**Response to reviewers for the paper “Absorption of VOCs by polymer tubing: implications for indoor air and use as a simple gas-phase volatility separation technique” Melissa A. Morris , Demetrios Pagonis , Douglas A. Day , Joost A. de Gouw , Paul J. Ziemann , and Jose L. Jimenez**

**Anonymous Referee #1**

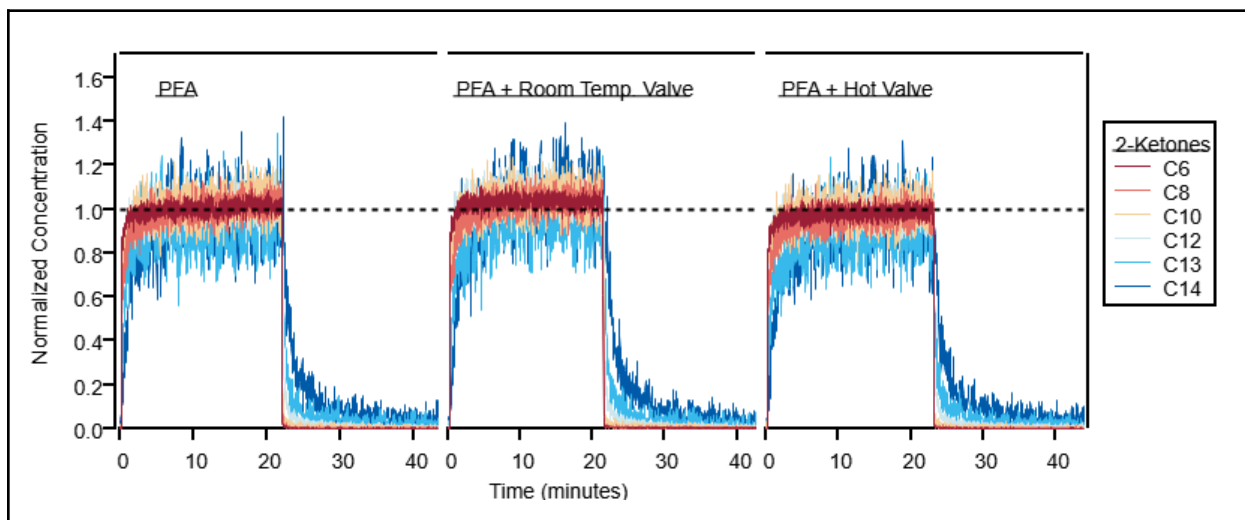
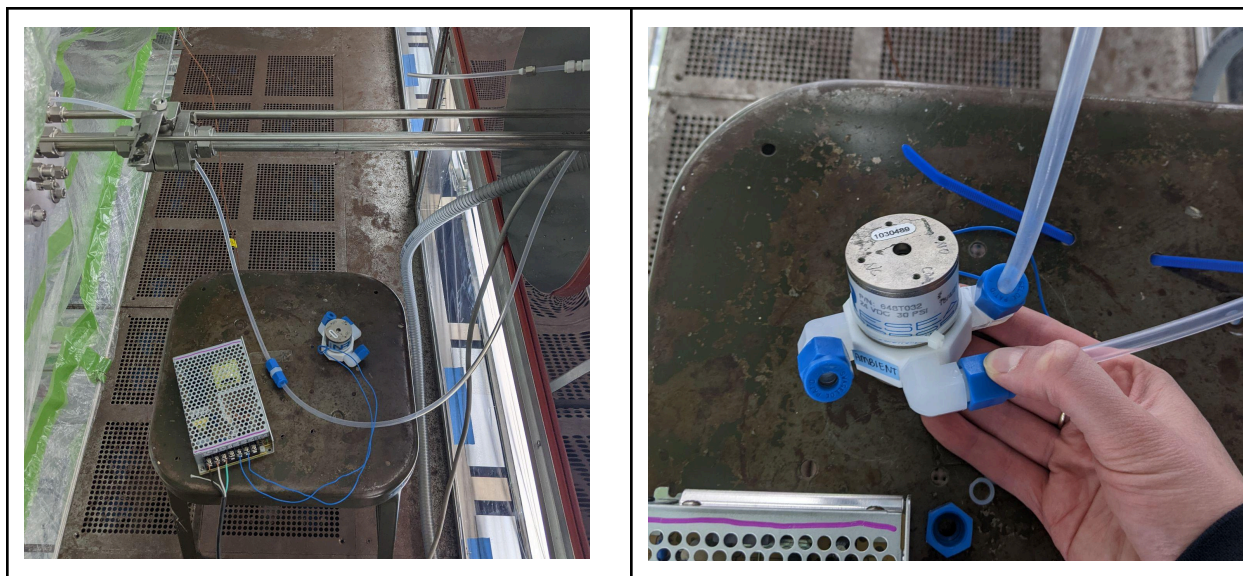
R1.6 Line 125. The Cole-Parmer 3-way solenoids have a fairly tortured flow path that can introduce delays and losses, even in PFA. Do the authors see a difference in delay times between PFA lines with and without these in line? An issue that has come up in many applications is the impact of these and similar valves on the sample flow stream, this seems like a good opportunity to examine the issue, which would be helpful for the gas sampling community. The authors allude to this on line 356.

To characterize the gas transmission of the 3-way solenoid valves, as suggested in this comment, we have completed an additional experiment. We found that the valves introduced only a minor additional delay for the least volatile species (on top of the PFA tubing delays). We have included the following figure and caption on page 13 of the SI:

**"While the 3-way solenoid valves could not be incorporated in the modeling runs, experiments showed that the solenoid valve effects on gas transmission are undetectable for  $C_{12}$  and more volatile species, and small for  $C_{13}$  and  $C_{14}$  ketones (see Figure S12)."**

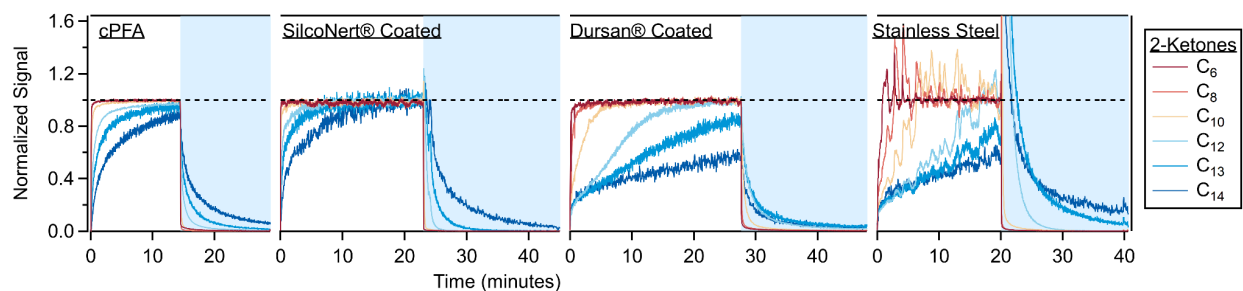
R1.10 Figure 7. It does not look obvious to me that silconert has a much slower response time than cPFA, though Figure 5 (and the text) says so. Am I just unable to see it clearly, or am I missing something. Also, the darkest blue line seems to be missing from cPFA during desorption, or maybe the colors are just different.

We agree that the absorption and desorption timescales of cPFA and SilcoNert are similar in Fig. 7. We had already included the lengths of tubing used in the caption, because they were not the same (149 cm for cPFA vs. 61 cm for the stainless steel tubes). When normalized to the tubing length, cPFA significantly outperforms SilcoNert.

We have replaced Figure 7 (updated figure shown below) to fix the coloring issue (the blue background had come forward, distorting the colors; the data did not change).

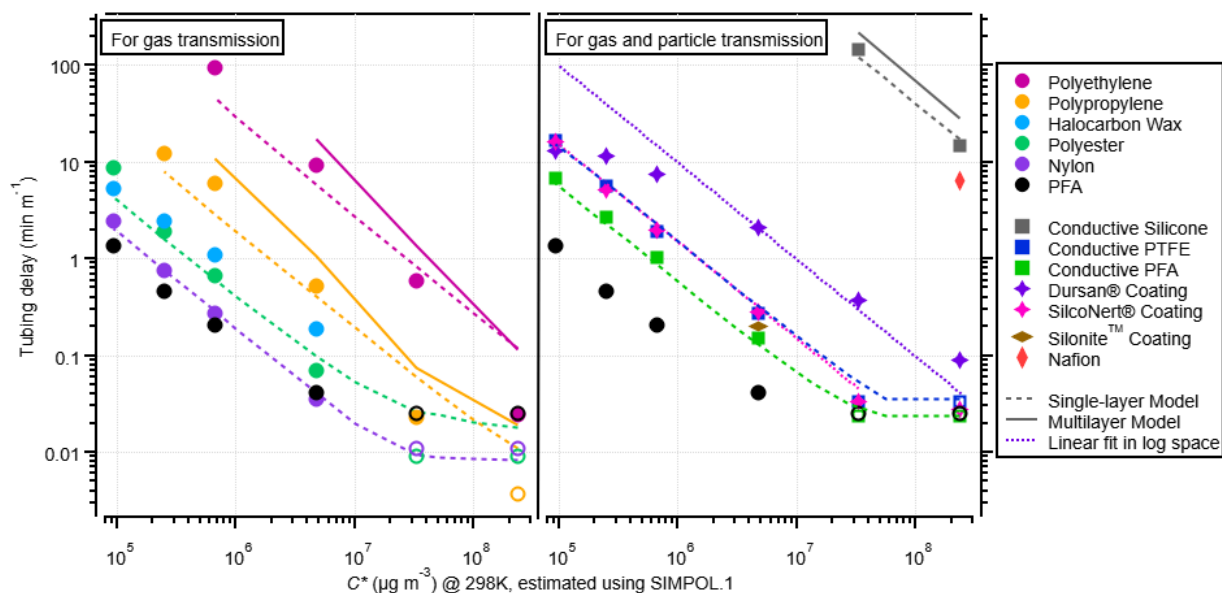
2. We have included gas transmission data on another material, a halocarbon wax coated glass tube. We have included manufacturing details for the material in table S2:

We updated Fig. 5 to include this material, reposted below:
